ADDENDUM #1

Project No.:	16-0023	Date:	January 4, 2019
Project:	Renovations for Community Education Center Portage Public Schools Kalamazoo County, Michigan	A/E Firm:	C2AE
Owner:	Portage Public Schools 8135 South Westnedge Ave. Portage, MI 49002	Project Manager:	Thomas McKercher
		Project Architect:	Gregg Jones
		Const. Manager:	Owen-Ames-Kimball

A1.5 Refer to Sheet M-501 (reissued):

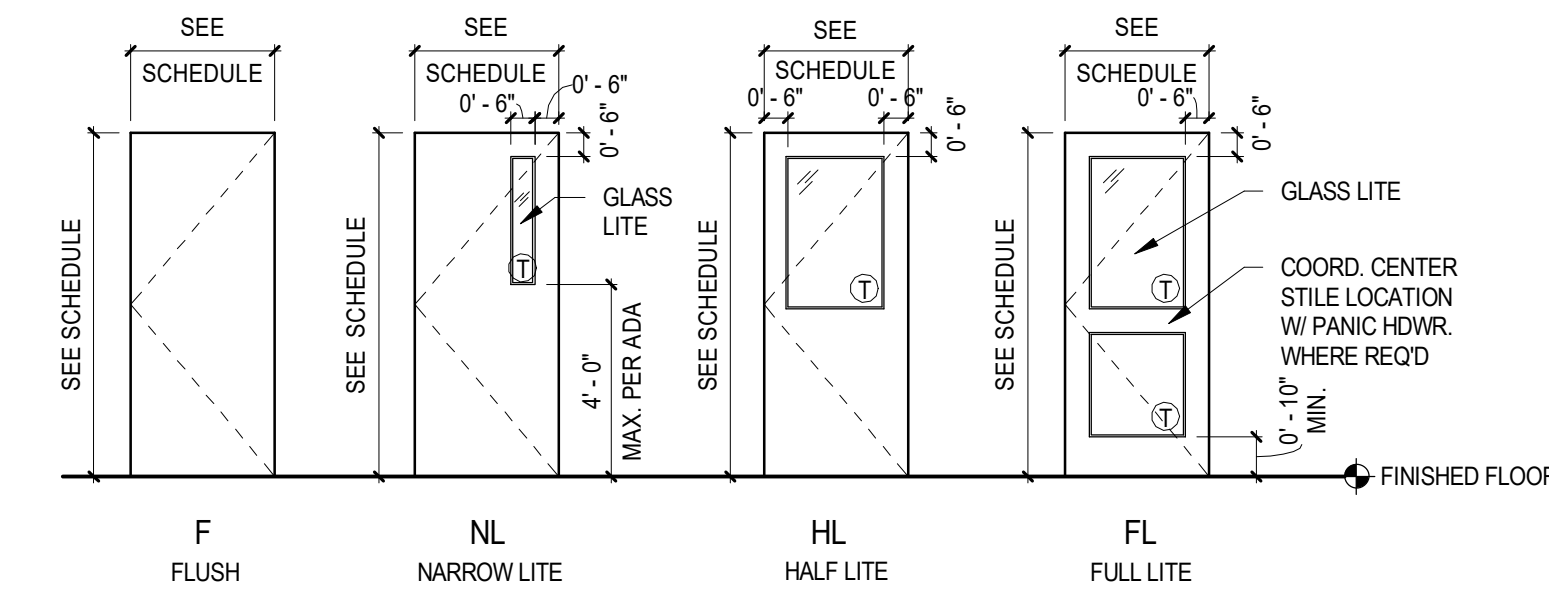
ADD Steam Coil Piping Detail.

DOOR TYPES
1/4" = 1'-0"

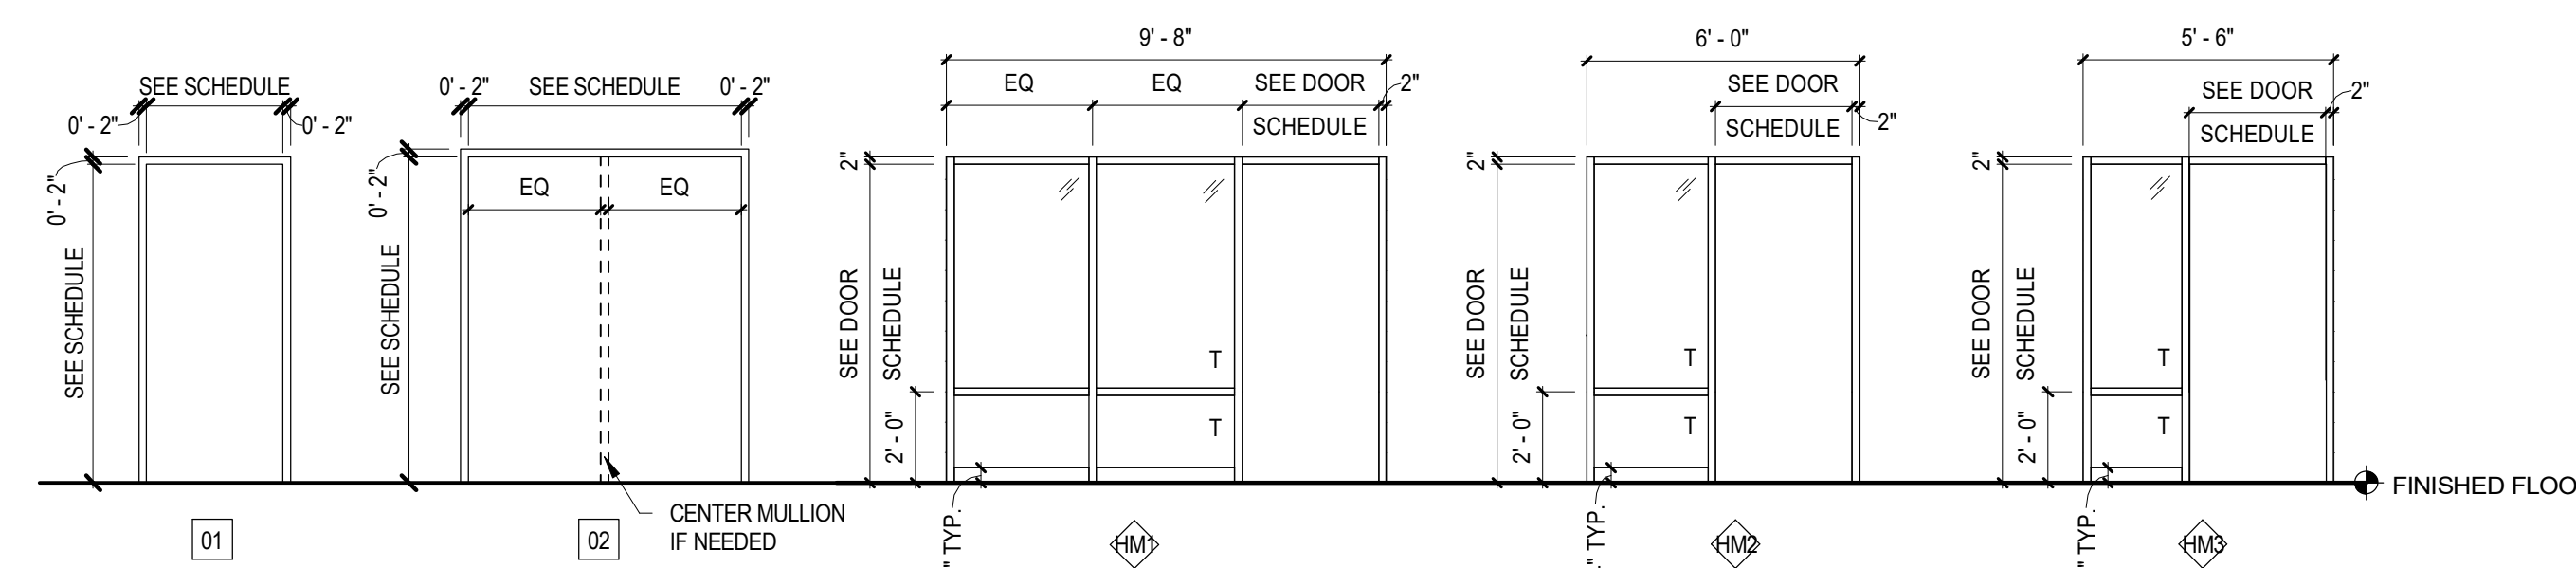
- All door types previously noted "FG" REVISE to be "FL".
- All door types previously noted "1" REVISE to be "HL".
- REVISE Openings 120.1, 120.2, 122A.1, 122B.1, and 137.1 to WD doors in HM frames.
- REVISE Opening 150.1 to FRP door (type HL) in AL frame.

PLUMBING PLAN - OVERALL
1/16" = 1'-0"

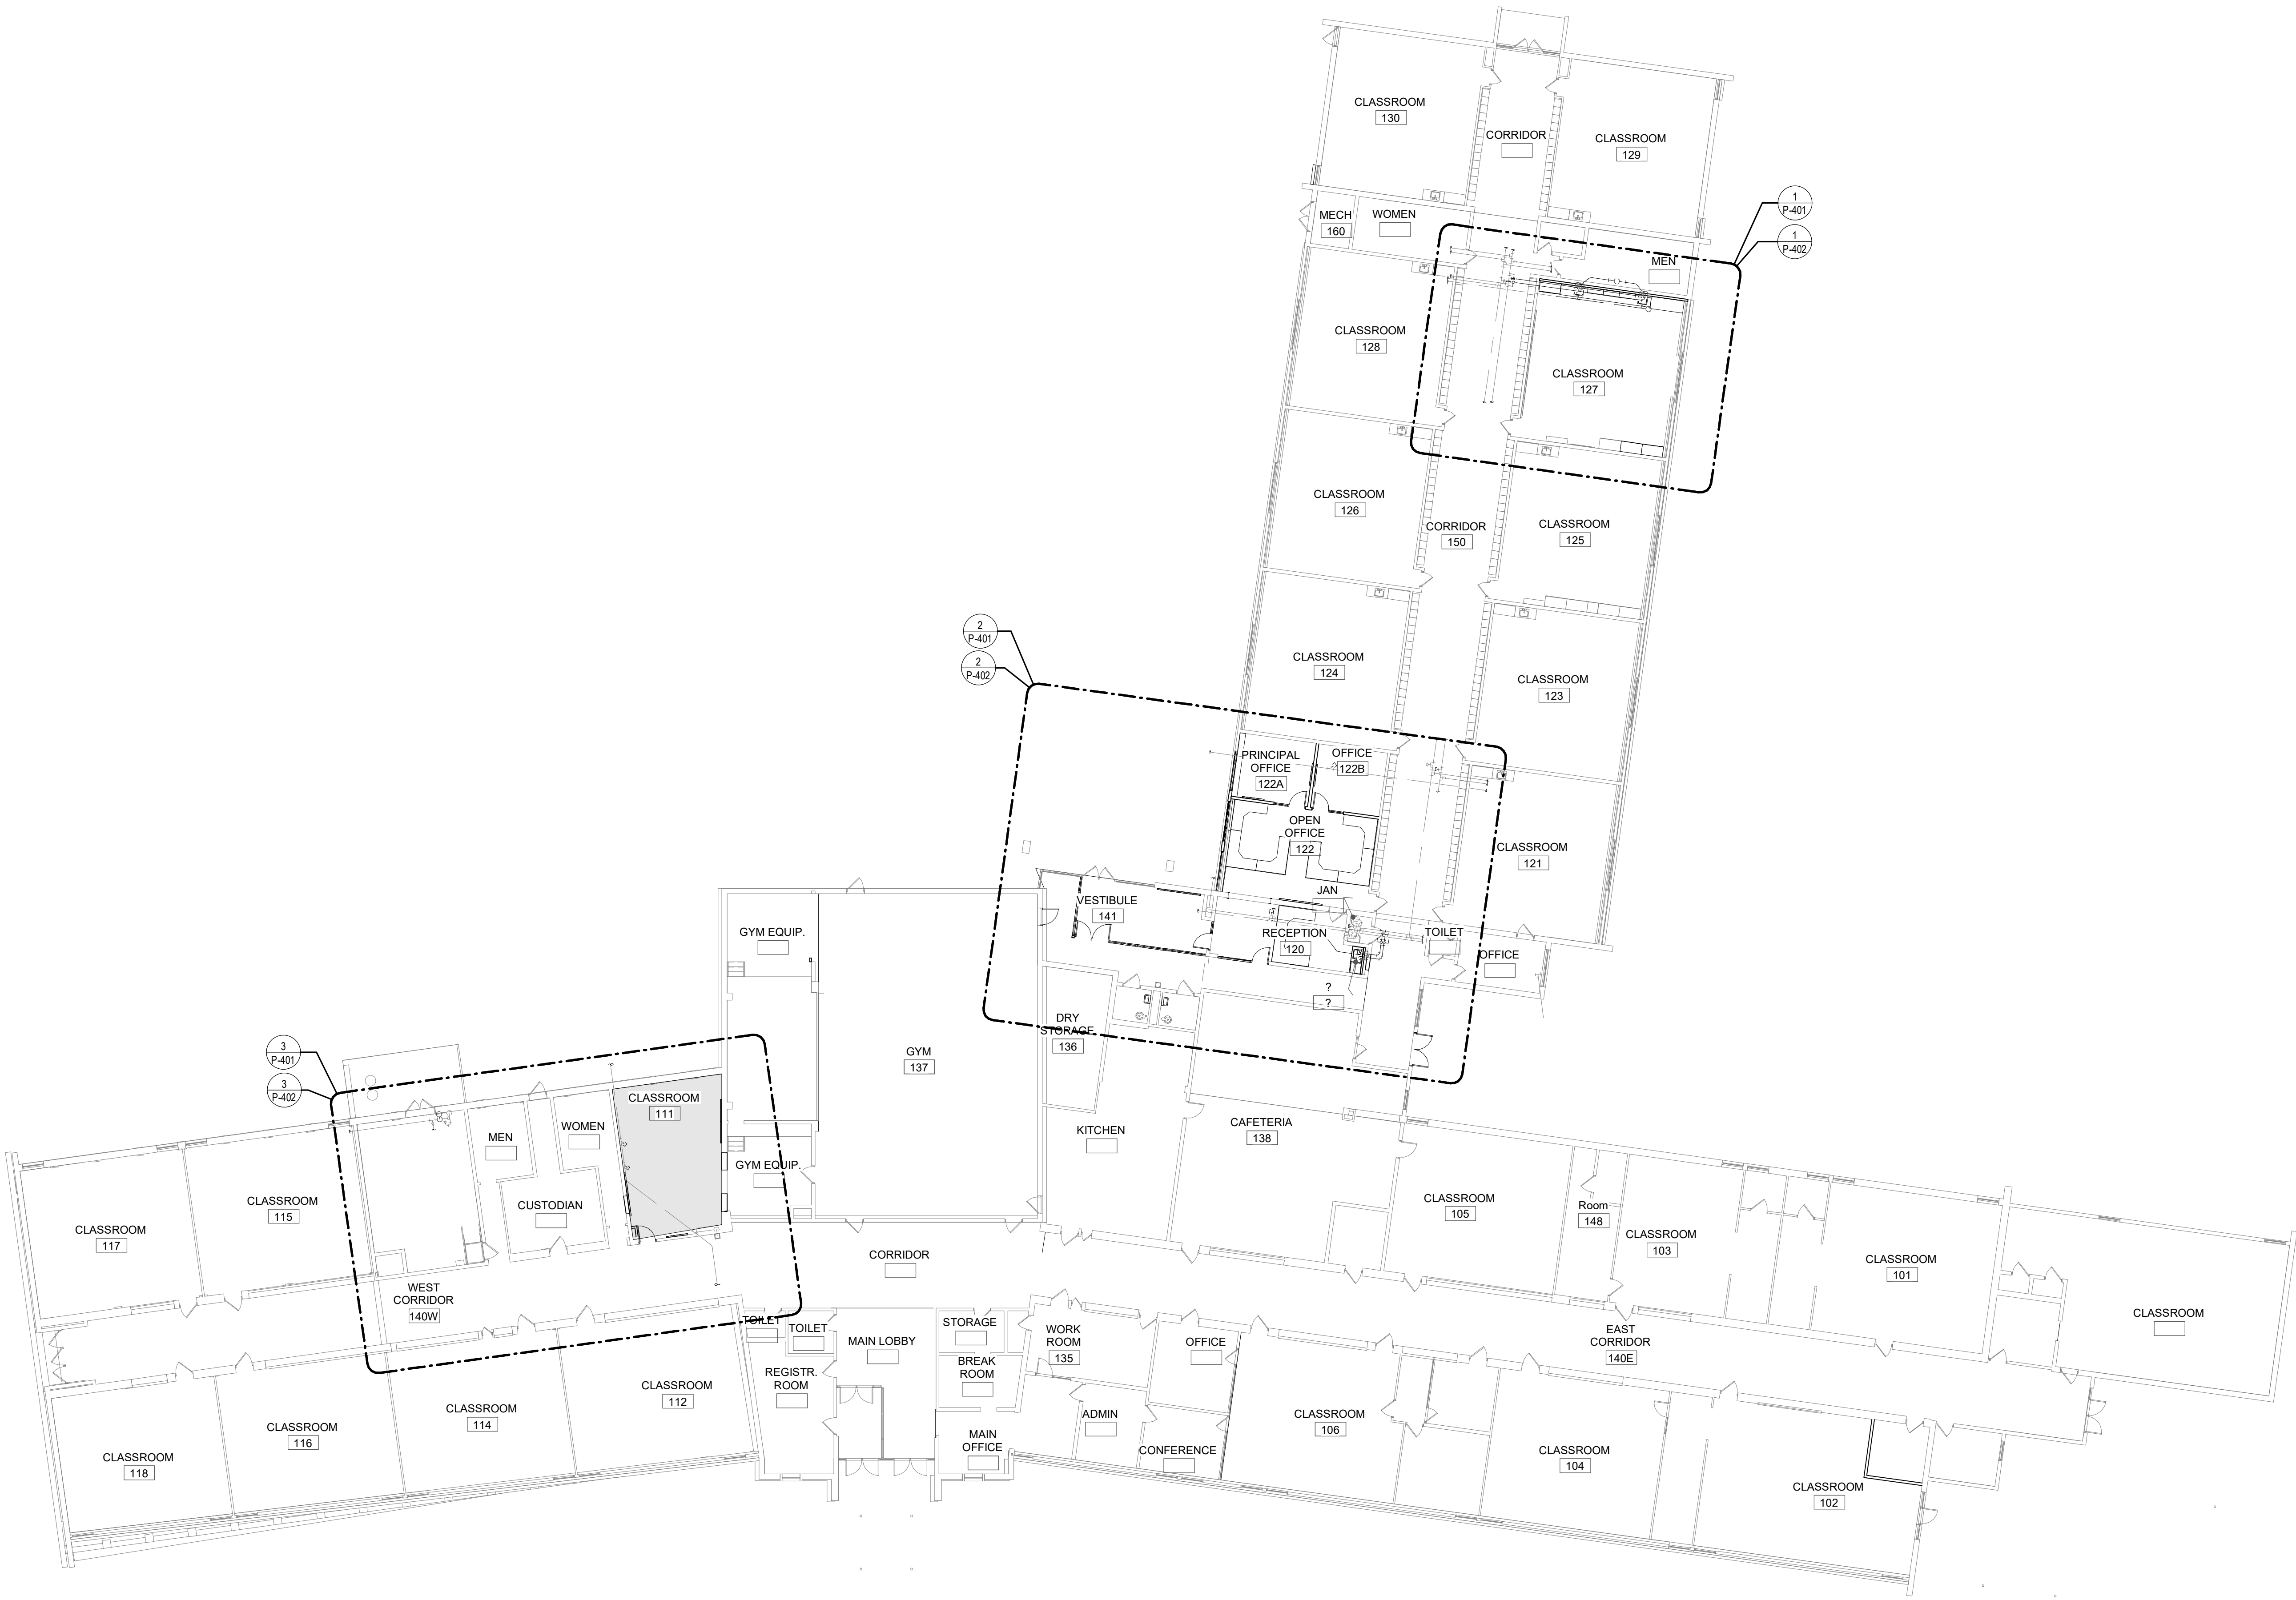
REVISED plumbing fixture schedule to include eyewash station in sink LS-1.
